NEDO-33147-A - Non-proprietary

LICENSING TOPICAL REPORT

DSS-CD TRACG APPLICATION

SUBJECT: FINAL SAFETY EVALUATION FOR GENERAL ELECTRIC NUCLEAR ENERGY (GENE) TOPICAL REPORT (TR) REVISION 1 TO NEDE-33147P, "DSS-CD TRACG APPLICATION" (TAC NO. MC1967)

Figure 4-1. Convective Terms at a Junction Between Components Using Different Numerical Methods.

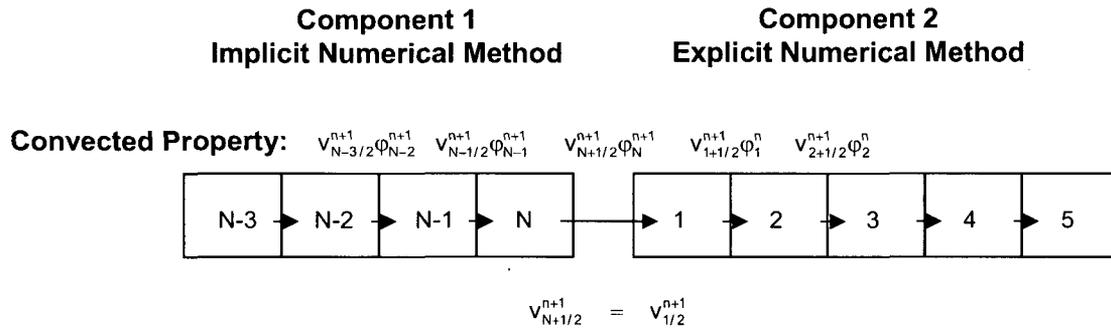
Effect of time level differencing for the change in momentum flux (i.e. V_{delV}) on transient results (see Eq. 3.2-8 in NEDE-32176P, Rev. 2)? The time level for the V_{delV} term is not consistent and will introduce error into the calculation. Is the error significant and will it grow with time?

However, in order to close out the issue, a sensitivity study has been performed where the convective term in the momentum equation was changed to use only old-time step properties, i.e., to a purely explicit form. The result of this sensitivity study is shown in Figure 5-1. It is seen that the impact of the form of the convective term in the momentum equation on decay ratio (or growth rate) is small, approximately [[]]. This sensitivity is insignificant compared to the [[]] margin applied in stability calculations.

Figure 13-1. Channel Rings used in the BWR/6 Instability Model

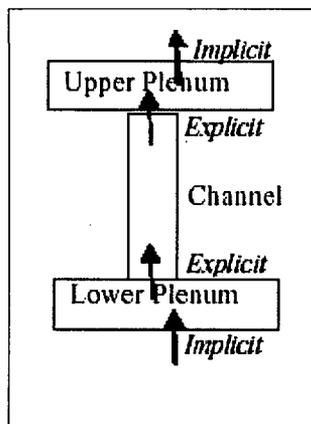
Please provide a figure of the channel grouping with the ring 1, 2, and 3 boundaries included. For example, Fig. 5-7 of NEDC-33075P, Revision 3 with the ring 1, 2, 3 boundaries included. NEDE-33147P, Draft B, Section 4.2.6, Page 4-5, implies that channel groups may include channels/bundles from both Ring 1 and Ring 2 of the TRACG vessel noding. The channel to vessel connections are apparently adjusted to ensure that the ratio of the number of bundles in Ring 1 to Ring 2 is roughly the ratio of the flow areas of Ring 1 to Ring 2. If this is to address channels/bundles that are on the boundary between the Rings 1 and Rings 2, then a more appropriate modeling method would be to assign the boundary bundles to either Rings 1 or 2, depending upon whether more of the channel is in Ring 1 or 2. The lower plenum, volumes and flow areas would be adjusted for Rings 1 and 2 consistent with the total number of channels/bundles that are actually simulated in rings 1 and 2. The channel grouping in Fig. 5-7 of NEDC-33075P, Revision 3 for channel group numbers 20 and 30, extends from the center of the core to the periphery of the core. Which of the 3 rings is channel groups 20 and 30 included into in the TRACG vessel model? If TRACG allows for multi inlet connections for a single CHAN component, then inlet connections for channel groups 20 and 30 can be spread across all three rings. If the fluid conditions in the lower and upper plenum are uniform in the radial direction, then this type of modeling approximation may not be important.

Figure 13-1 shows the ring boundaries imposed on the channel grouping for BWR6 Instability Event. In this model, which is typical for stability modeling, only two rings are used; an inner ring and one for the peripheral channels. In this case, all but the peripheral channels are assigned to Ring 1. [[
